Report to Development Permit Panel

DP 16-740262

Application by 0989705 B.C. Ltd. for a Development Permit at

7960 Alderbridge Way and 5333 & 5411 No. 3 Road

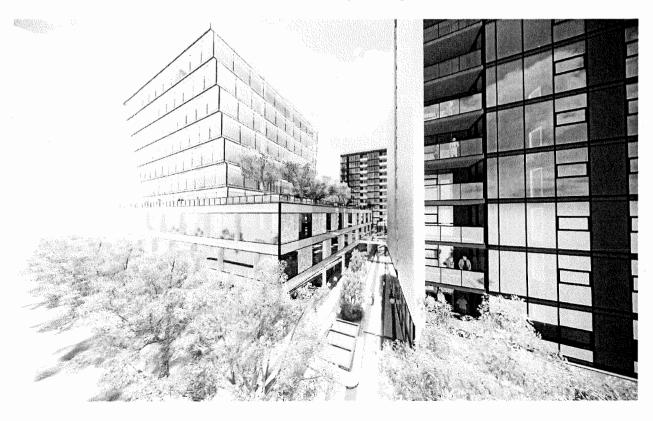
- pedestrian crossing from No. 3 Road to the new north-south road through the central plaza will enhance the Lansdowne Village neighbourhood and distinguish the area as a distinct place;
- appreciate the signage plan and wayfinding strategy for the project; and
- consider differentiating more the residential entrances from the retail and public spaces through further articulation.

GBL Response:

The project team developed differentiating colour/material themes for the towers (See figure 1)

These themes are being expressed in the following building materials within the entrance lobbies on level 1 and the amenity areas on level 10

- o Feature Ceiling
- o Balcony Soffits
- o Flooring
- o Feature Wall
- o Coloured Glazing in curtain wall
- o Coloured glazing in entrance canopy
- Address Signage
